# Access Compliance Report

## Public Rights-of-Way

Intersection ID: 25420	Main Street: MCPHERSON_DR	Cross Street: WYMAN_LN	Location: SW
ADA ID: DFEE539DDC9F	Ramp Type: Directional1	Initial Pass/Fail: Fail	Overall Compliance: No
Codes/Mitigation Info/Possible Solution		Field Measurements/Component Compliance	
Severity Score: 10

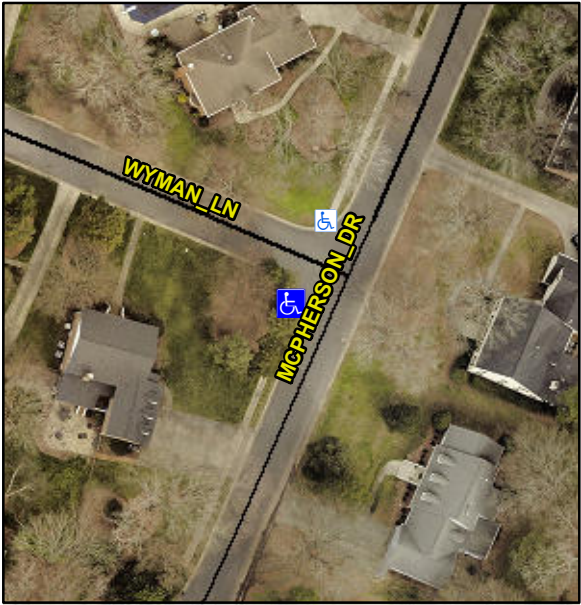
Possible Solutions:				
	Remove & Replace Entire Ramp.				
	Surveyor Notes:				
	N/A				
	PROW/ADA:				
	R304.5.1, R304.5.3				
	Street 1 Name	WYMAN LN			
	Stop Condition-Street 1	StopSign			
	Street 2 Name	N/A			
	Stop Condition-Street 2	N/A			
Total Cost:		\$	1600.00		
		Compliance	Description	Data	Compliance Description Data
		N/A	Ramp Length (in)	64.0	N/A Grade Break? N/A
		No	Ramp Width (in)	42.0	N/A Grade Break Slope (%) 0.0
		Yes	Ramp Slope (%)	1.4	N/A Grade Break XSlope (%) 0.0
		No	Ramp XSlope (%)	2.3	
		N/A	Flare Type LT	N/A	N/A Flare Type RT N/A
		N/A	Flare Slope LT (%)	N/A	N/A Flare Slope RT (%) 0.0
		N/A	Flare Traversable LT?	N/A	N/A Flare Traversable RT? N/A
		N/A	Landing Length (in)	0.0	N/A DWS Provided? N/A
		N/A	Landing Width (in)	0.0	N/A DWS Contrast? N/A
		N/A	Landing Slope (%)	0.0	N/A DWS Length (in) N/A
		N/A	Landing X Slope (%)	0.0	N/A DWS Full Width? N/A
		N/A	Landing Curb? (Y/N)	N/A	N/A DWS Offset LT (in) N/A
